Spieker Development Project Excavation and Bedrock Impacts

Seven Hills Ranch
 Proposed Spieker Senior Continuing Care Community
 Contra Costa County CA
Bedrock Presence Map

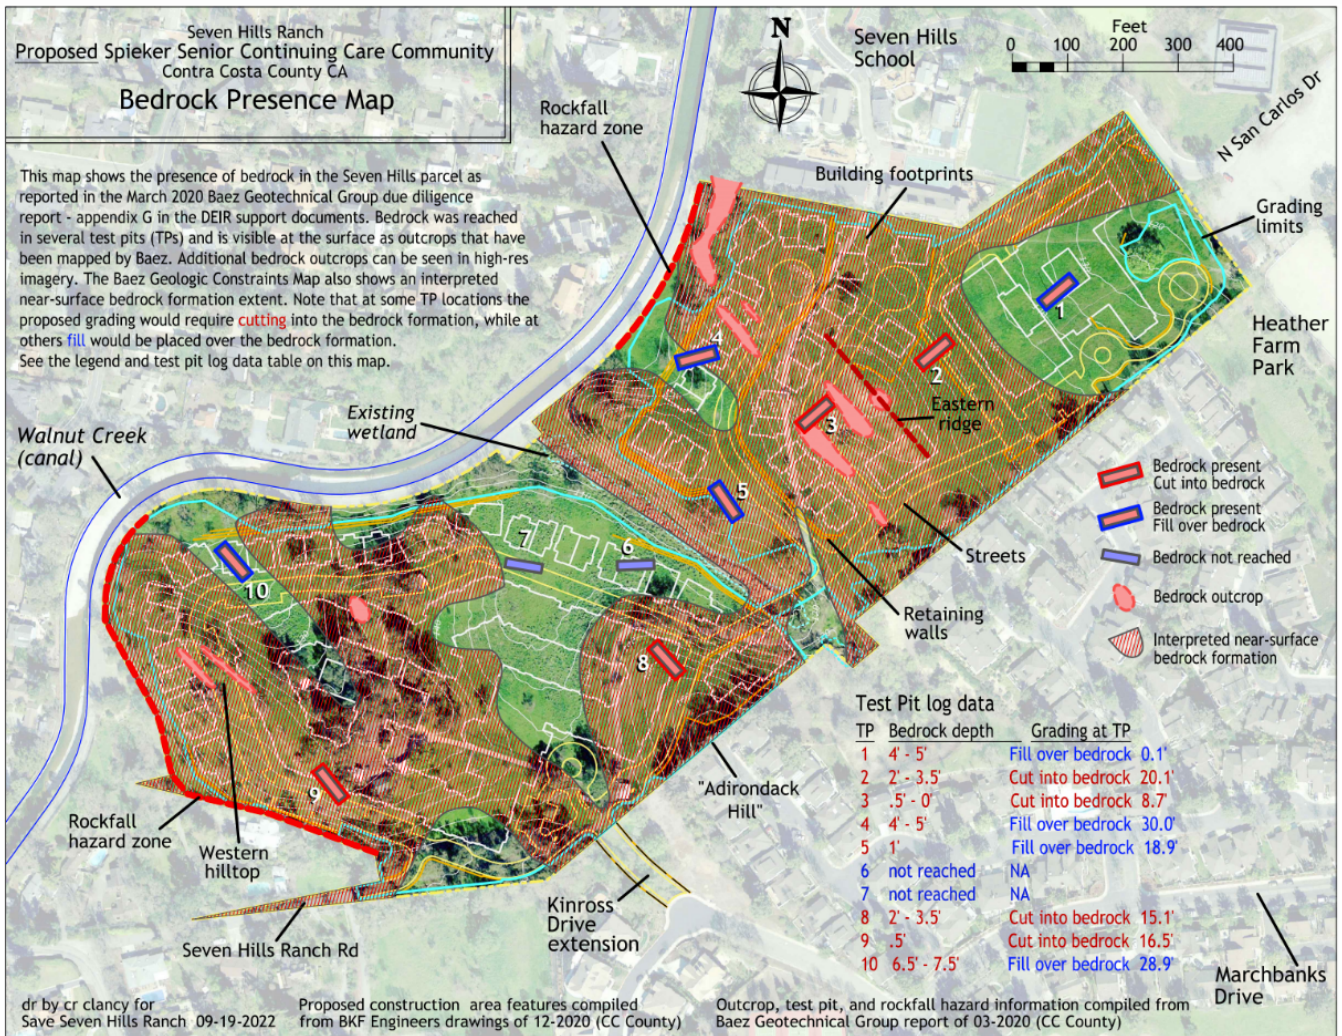
To accommodate the proposal's largest building and its surrounding villas, the western hill would be leveled by cutting up to **28 feet depth** of bedrock, for the maintenance building over **20 feet depth** of bedrock would be cut from the existing hill and the plan calls for recontouring the eastern ridgeline, starting with **removal of the top 11 feet**, again, much of it composed of bedrock.

The [Spieker Proposal](#) minimally addresses the bedrock issues. The Draft EIR discusses bedrock under existing conditions and mitigation measures but concludes that the impact would be "*Less than significant...with mitigation incorporated*". This is a suspect conclusion given the existing terrain and the amount of landscape reconfiguration required for the proposal.

The project's bedrock disturbance WILL have SIGNIFICANT impact should it go through as proposed.
